Safety Defect and Noncompliance Report Guide for Vehicles  
**PART 573 Defect and Noncompliance Report<sup>1</sup>**

Furnish the manufacturer's identification code for this recall (if applicable): RCN-040312

**AD-100 Door Motor Assembly**

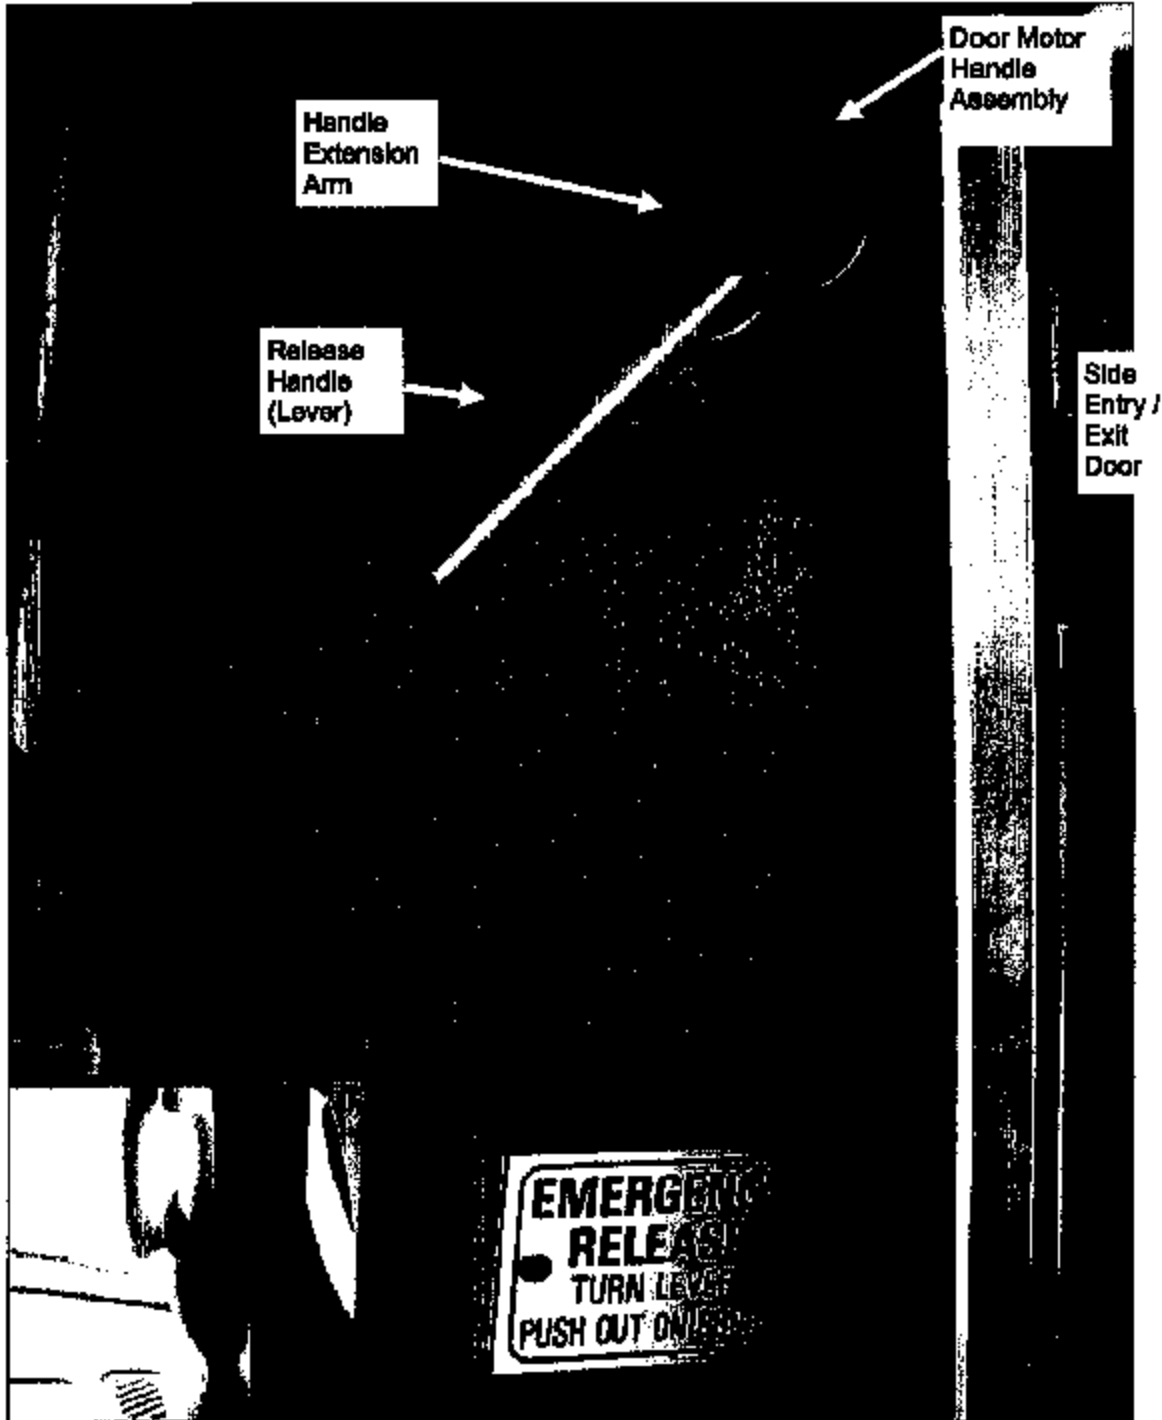
THE ELECTRIC DOOR MOTOR ASSEMBLY HANDLE (LEVER) COULD POSSIBLY BREAK WHEN PULLING ON THE HANDLE FOR EMERGENCY RELEASE TO OPEN THE SIDE ENTRY/EXIT DOOR. THE HANDLE IS LOCATED ON THE INSIDE OF THE VEHICLE ON THE FRONT BULKHEAD WALL (UPPER PASSENGER SIDE) ADJACENT TO THE SIDE ENTRY/EXIT DOOR. CENTER OF HANDLE ASSEMBLY IS 59" UP FROM VEHICLE FLOOR. ATTACHED IS PICTURE OF DOOR MOTOR ASSEMBLY EMERGENCY RELEASE LEVER AS INSTALLED IN FINISHED VEHICLE.

HANDLE BREAKAGE COULD POTENTIALLY OCCUR ON EXTENSION ARM WHERE HANDLE BODY ATTACHES TO DOOR MOTOR ASSEMBLY. EXTENSION ARM COMPONENT MATERIAL COMPOSITION OUT OF SPECIFICATION.

RECALL HANDLE EXTENSION ARM IS MADE OF ALUMINUM. REMEDY  
HANDLE EXTENSION ARM IS MADE OF STAINLESS STEEL. ACTION TO RELEASE  
THE DOOR MOTOR ASSEMBLY FOR RECALL HANDLE IS TO PULL WITH DOWNWARD  
ANGULAR FORCE ON HANDLE. REMEDY HANDLE ACTION IS TO TURN THE  
HANDLE. TAKES MORE FORCE TO PULL ON HANDLE THAN TO TURN NEW  
HANDLE. ATTACHED IS PICTURE OF DOOR MOTOR ASSEMBLY EMERGENCY  
RELEASE HANDLE REMEDY.
